NUREG-1790, Vol. 2

# **Environmental Impact Statement for the Proposed National Enrichment Facility in Lea County, New Mexico**

**Appendices H through J**

**Final Report**

Figure E-8 Average 24-Hour Concentrations of Pollutants in Extreme Winds from the West-Southwest

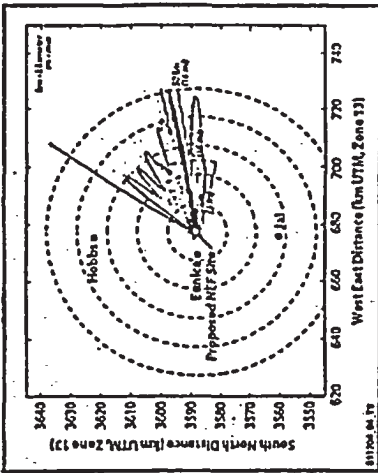
93. Page E-3, line 7 - The reference to "National Weather Station" should be "National Weather Service Station."
94. Page E-4, lines 64 and 65 - This sentence refers to Figure E-8 and states "This figure shows that a narrow plume would extend to the west from the proposed NEF source." However, Figure E-8 shows the plume extending to the east of the NEF site. Therefore, the sentence should be revised to "This figure shows that a narrow plume would extend to the east from the proposed NEF source."
